DRAINAGE LETTER REPORT

**WOODFORD MANUFACTURING BUILDING ADDITION
LOT 1, BLOCK 1, WAYNOKA ROAD INDUSTRIAL
2121 WAYNOKA ROAD, COLORADO SPRINGS, CO**

**JPS Project No. 051801
PPR-18-00**

18-037

DEVELOPED DRAINAGE PLAN

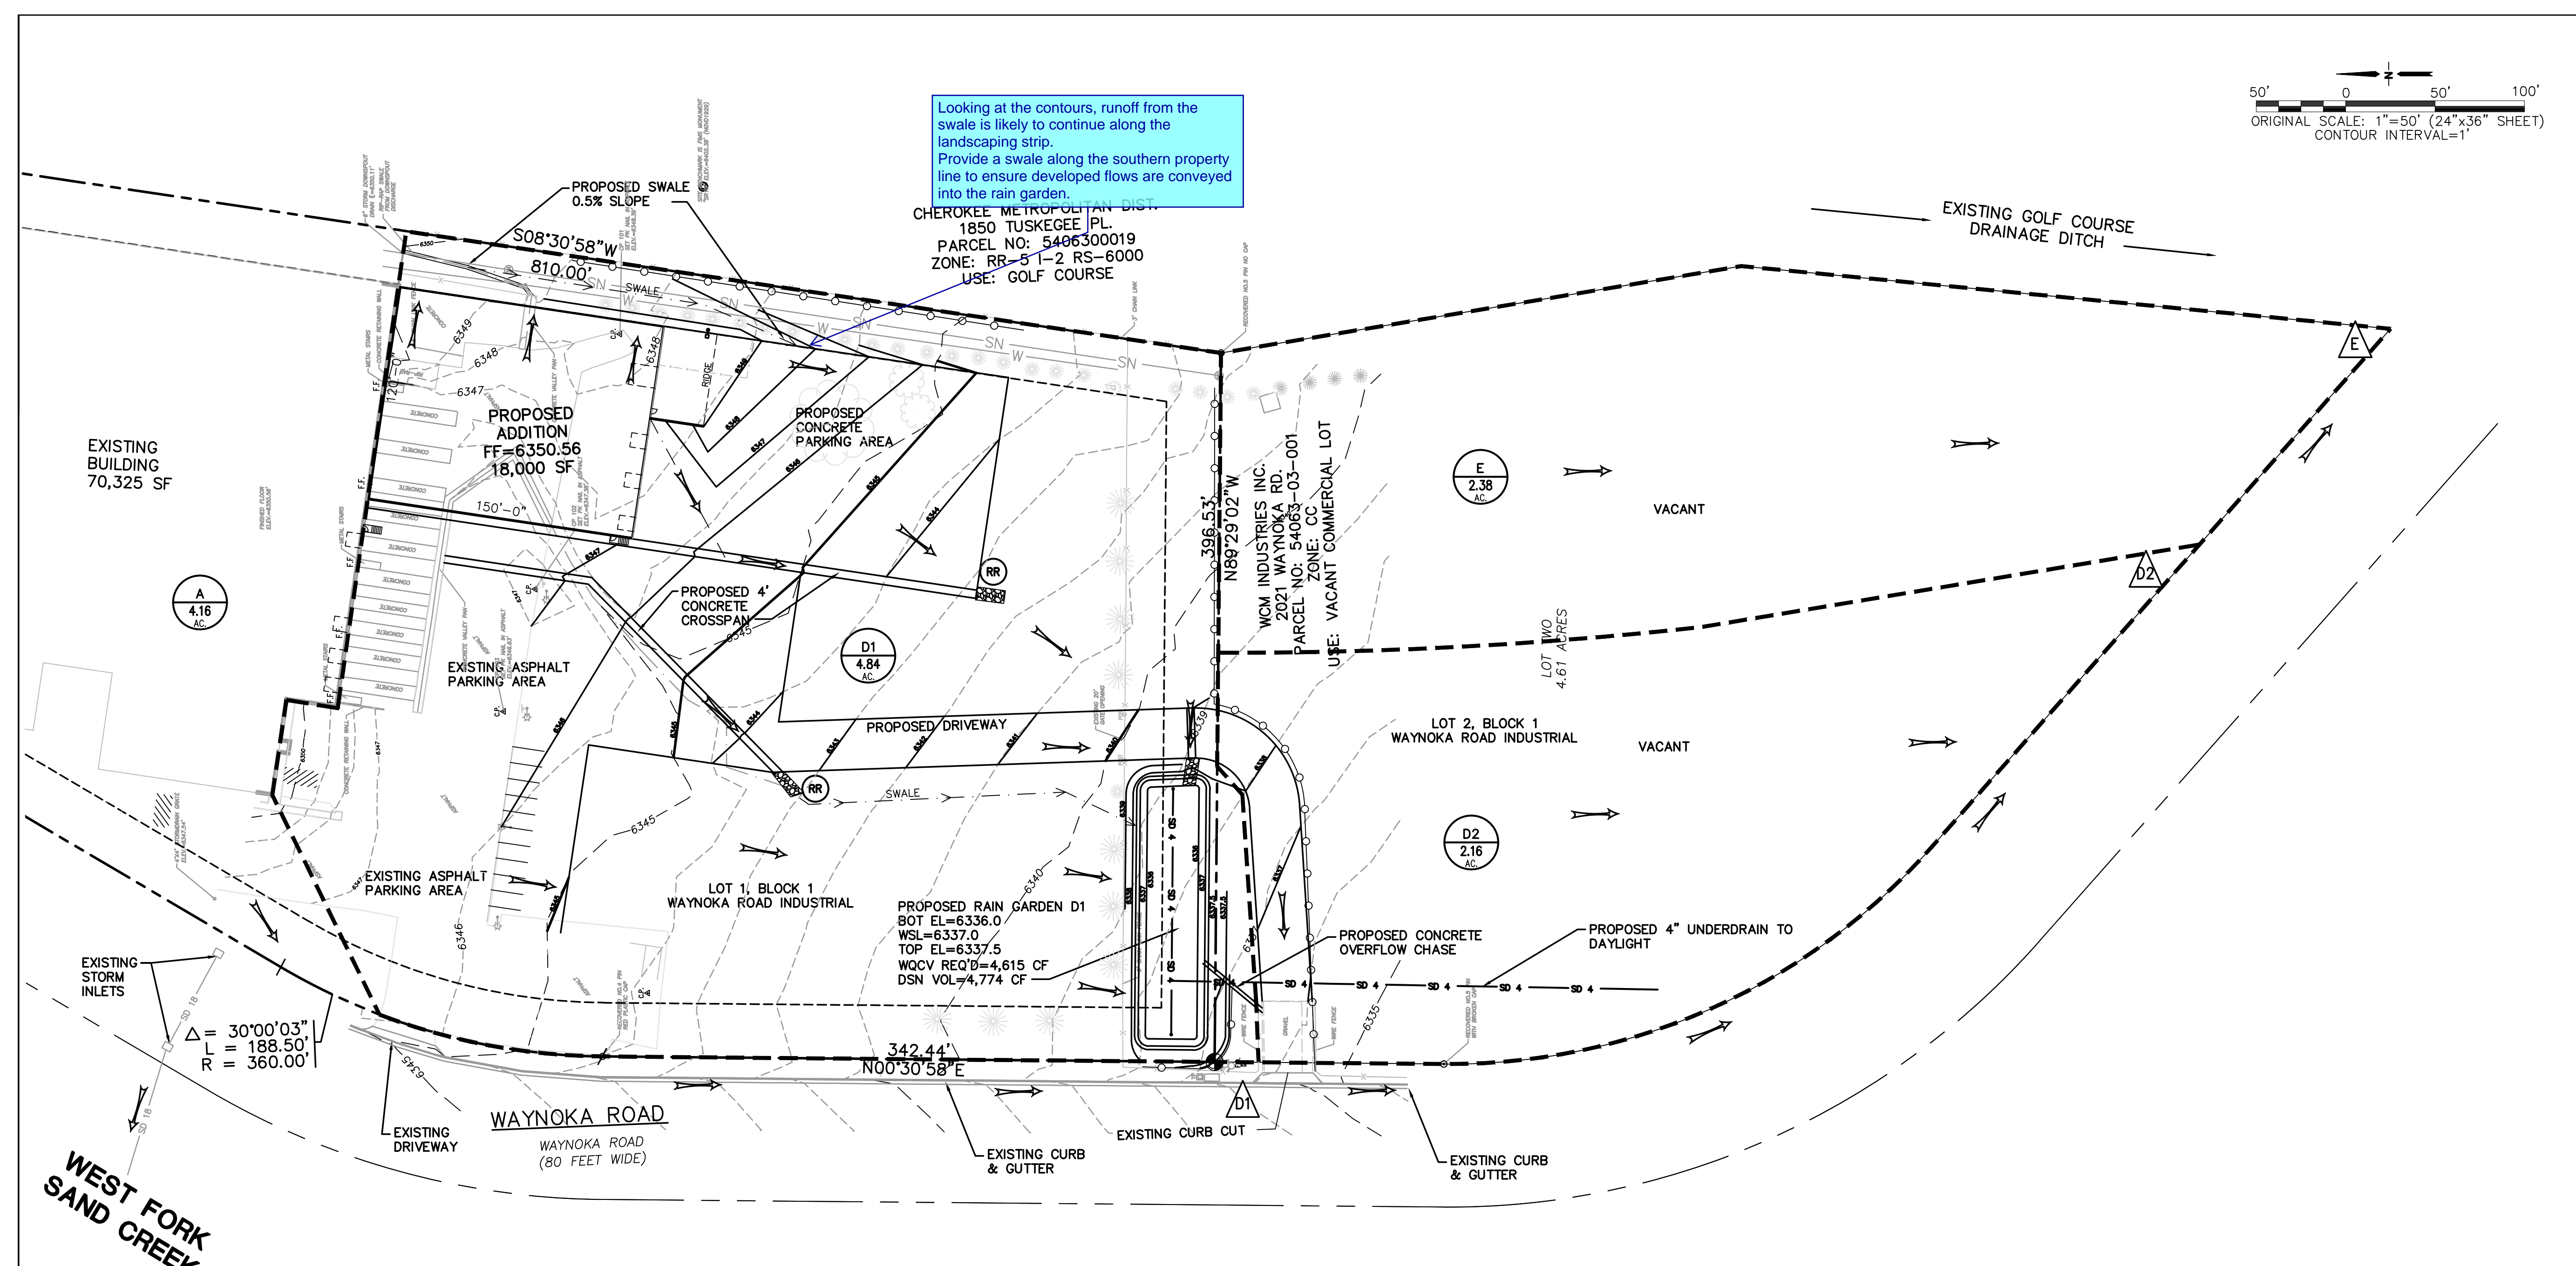
Looking at the contours, runoff from the swale is likely to continue along the landscaping strip.
Provide a swale along the southern property line to ensure developed flows are conveyed into the rain garden.

Looking at the contours, runoff from the swale is likely to continue along the landscaping strip. Provide a swale along the southern property line to ensure developed flows are conveyed into the rain garden.
